## **BRANCHWOOD SUBDIVISION, RESUBDIVISION** **OF LOT 3**

APPLICATION NUMBER 8 DATE November 6, 2003

APPLICANT Branchwood Subdivision, Resubdivision of Lot 3

# BRANCHWOOD SUBDIVISION, RESUBDIVISION OF LOT 3

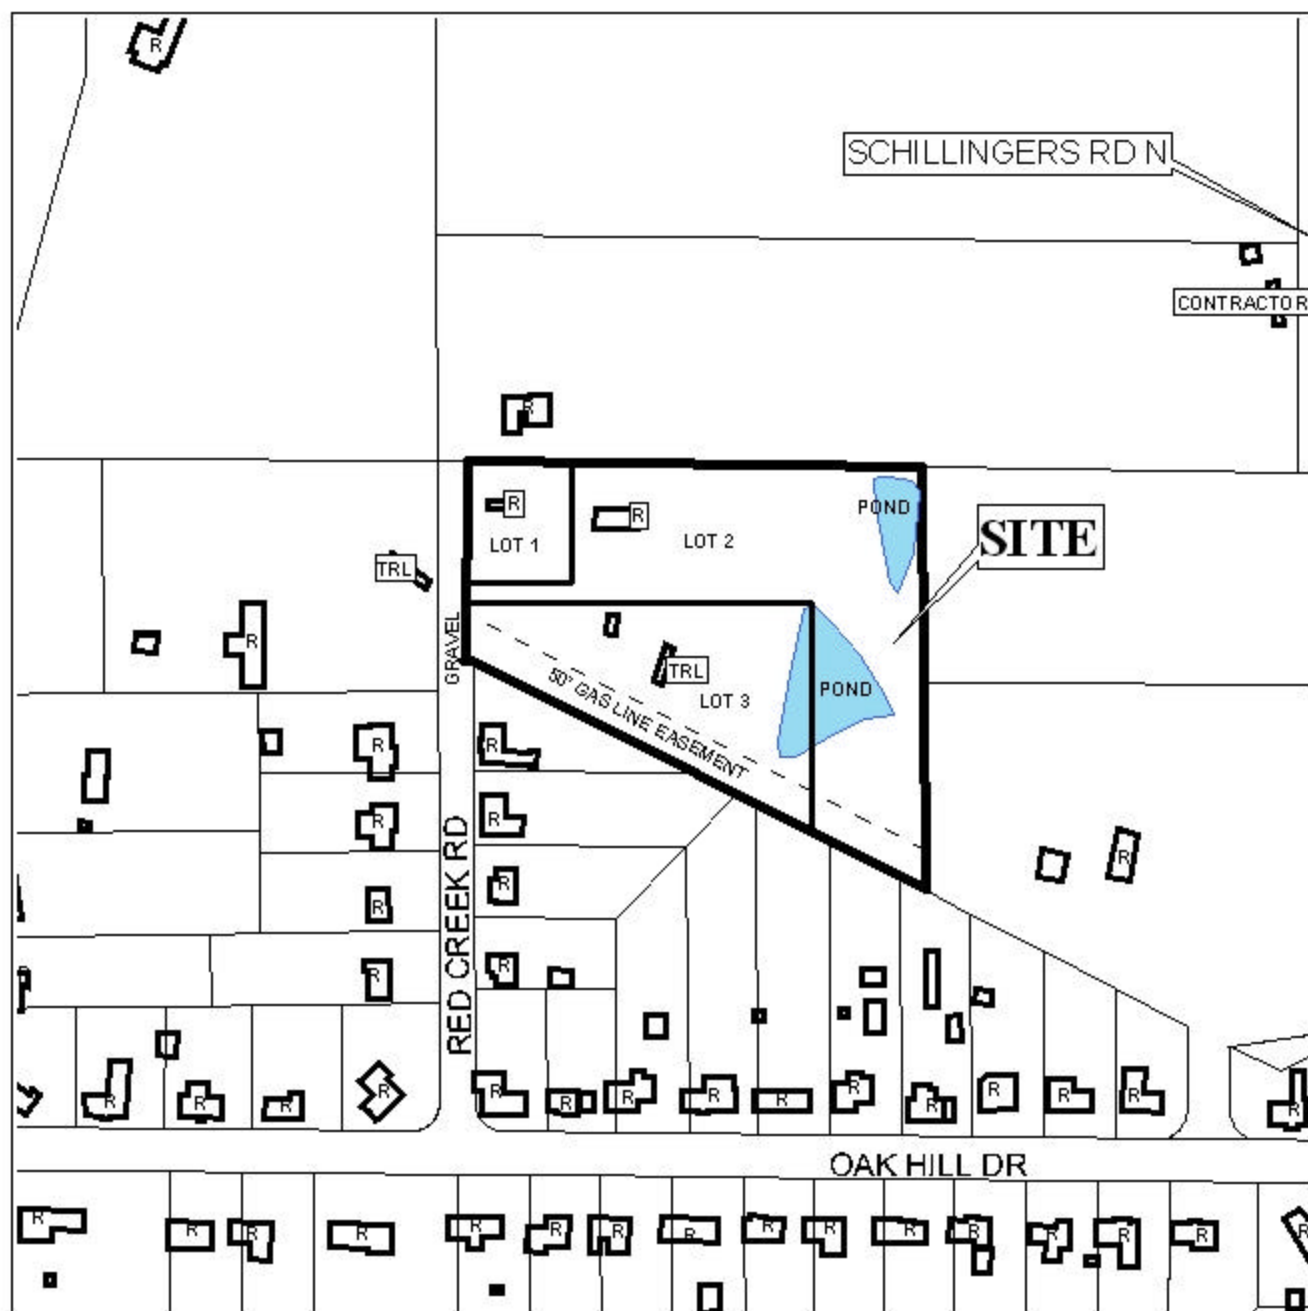
As a method of access management, the placement of a note on the final plat stating that the size, location and design of all curb cuts to Red Creek Road must be approved by County Engineering, should be required.

This site is located in the County, thus a note should be placed on the final plat stating that any lots which are developed commercially and adjoin residentially developed property must provide a buffer, in compliance with Section V.A.7. of the Subdivision Regulations.

The 25-foot minimum setback lines are not shown but would be required on the final plat.

Also, as indicated on the Vicinity Map, Red Creek Road is a gravel road that is substandard. As a matter of policy, the Planning Commission typically does not approve subdivision on dirt roads that increase the number of lots accessing the dirt road.

Based on the preceding, this application is recommended for denial for the following reason: 1) the application would increase the number of lots on a substandard (dirt) road.
